From: Wagland, Robin (WSP Environmental, Milton)
Sent: Friday, 24 April 2009 10:27 AM
To: Jeremy Wicks
Subject: Cronulla Park SAP

To: SKM
Attention: Jeremy Wicks
Fax No: 07 3026 7100
From: Robin Wagland
Date: 18 August 2009
Our Ref: 2-09-007
Pages: 3
Re: Interim Summary Report on Supplementary Site Investigation - TPR Review

Response to TPR Comments “Contaminated Site Investigation, Logan Greyhound Racing Facility, Cronulla Park”

**Logan Greyhound Facility, Slacks Creek,
Queensland (Lot 658 on Plan SL12298)**

LOCALITY: BLACKS CREEK
LOGAN GREYHOUND FACILITY
GROUND SITE INVESTIGATION
Figure 3
Existing Topography & Drainage Patterns

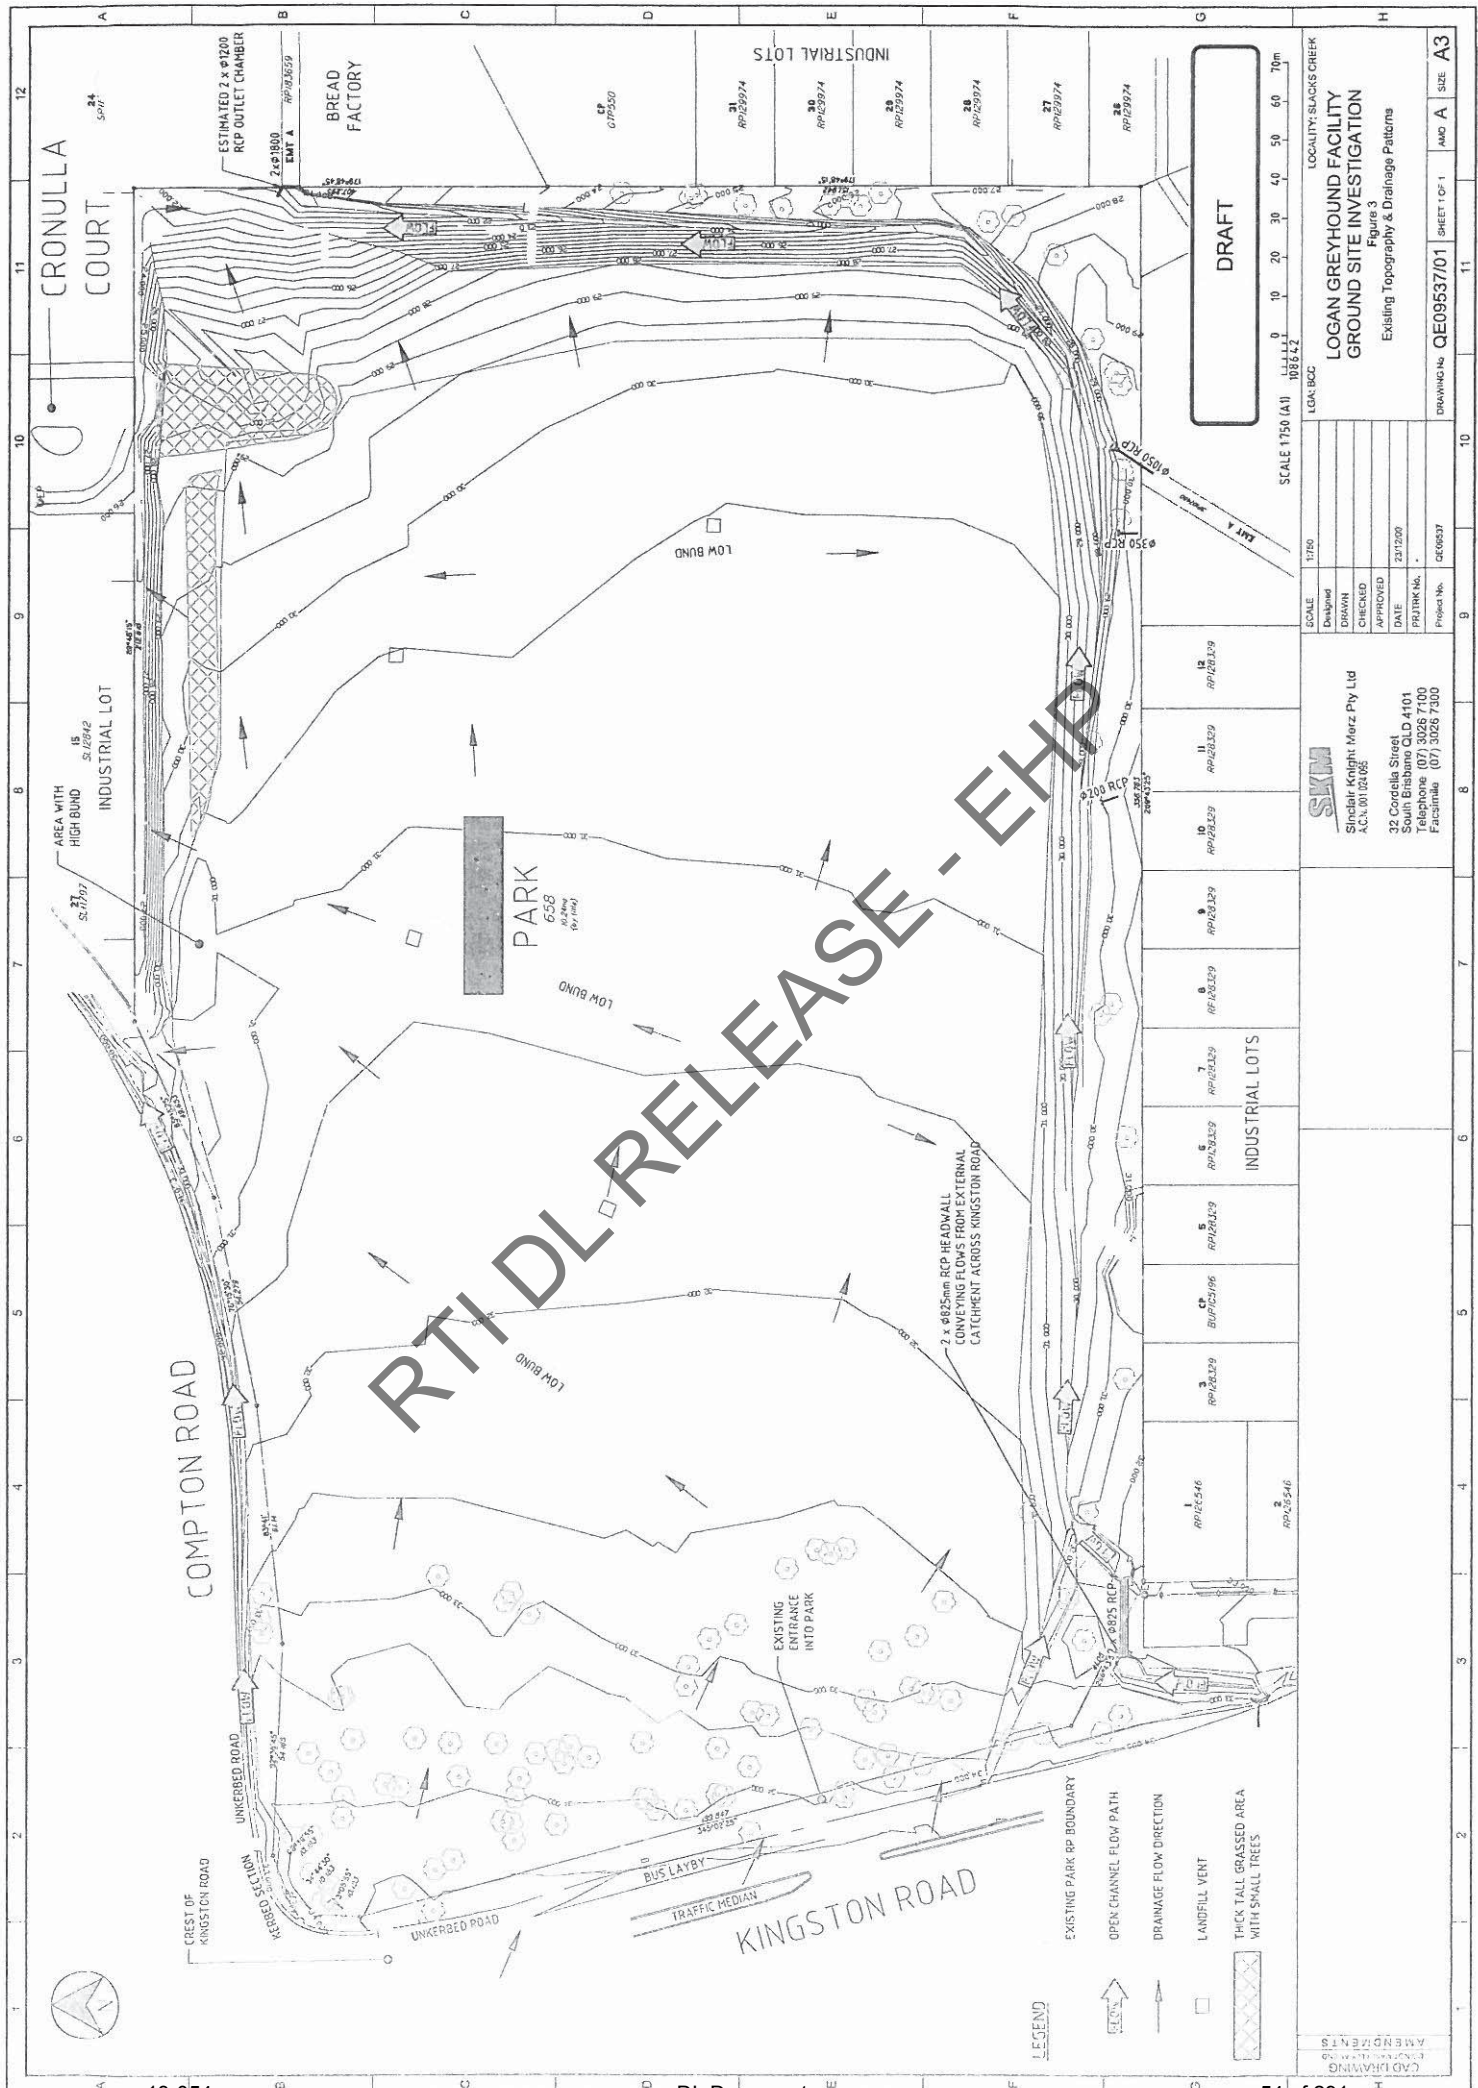
Scale bar states 1:750 at A1, yet scale in title is 1:750 and print out is A3 – please clarify/amend.

- Figure has been corrected.
